**SUBJECT:** Staff Response to PBMVC Referral of Legistar File 24357 on the Proposed Amendment to the Sprecher Neighborhood Development Plan

Recommended Changes to  
Proposed Sprecher Neighborhood Development Plan  
11-16-11

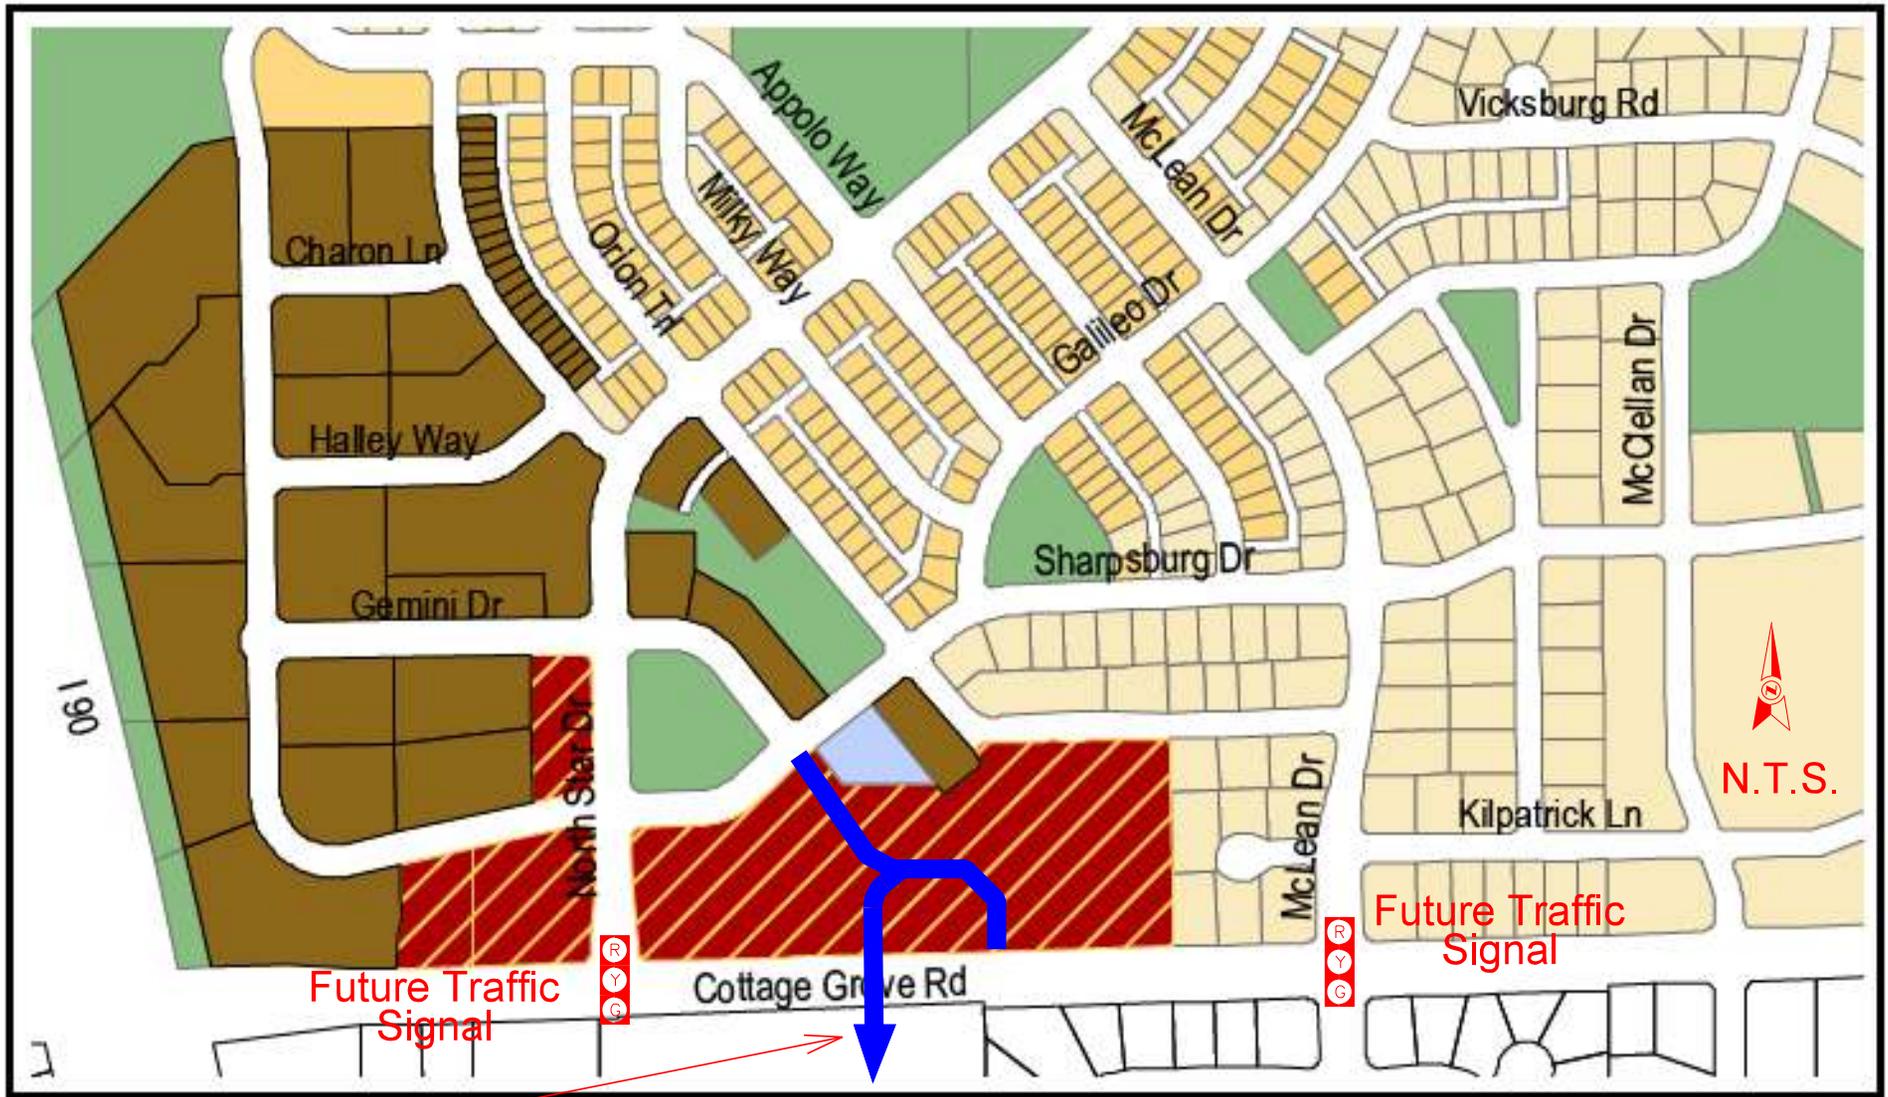
Given the information available, TE staff recommend that the subject NDP Amendment be revised for several elements. Part of the problems with the current proposed amendment (and related GDP site plan) is that it does not provide a good or functional street or traffic plan. While the specific GDP provides internal private access lanes, it does not provide a strong enough and connected enough grid street or main street needed to support the proposed development and adjoining neighborhood. The proposal is called a "town center" but elements like a public main street are absent, thus the plan is not very well integrated and connected with the neighborhood and street system. The current plan also does not plan for or provide for reasonable and orderly development and access for the lands on the south side of Cottage Grove Road. A better and stronger public street plan and access management plan is required.

The main TE staff recommendation is that the NDP (and related GDP site plan) be amended to provide a main street or public street through the site for several reasons:

- a. To provide adequate capacity, function, & connections for the site itself;
- b. To provide adequate capacity, circulation, & linkage to the approved, forthcoming traffic signal at North Star Drive for safe & manageable traffic control;
- c. To reduce unmanageable traffic & conflicts directly in front of a planned grocery store & same location as exiting & entering main source of site traffic on CTH BB;
- d. To provide a full complement of ped-bike, urban features of a public street;
- e. To align it properly to the south side of Cottage Grove Rd to orderly serve that parcel in the future; &
- f. To attain higher order recognition by Dane Co Hwys for access approval (public streets are given higher consideration).

A second TE staff recommendation is that the NDP and related GDP be amended to include or provide a ped-bike master plan for the site and surrounding neighborhood. Such a plan would show linkages and connections in all directions, and also provide detail plans of the specific ped-bike facilities intended to be built, such as bike lanes, bike (shared) paths, bike parking, etc.. For example, how would a family with children bicycle to the proposed grocery store from Mclean Drive in a way that they feel safe and secure?

The **attached map** illustrates the recommended public main street plan.

Proposed Public Streets
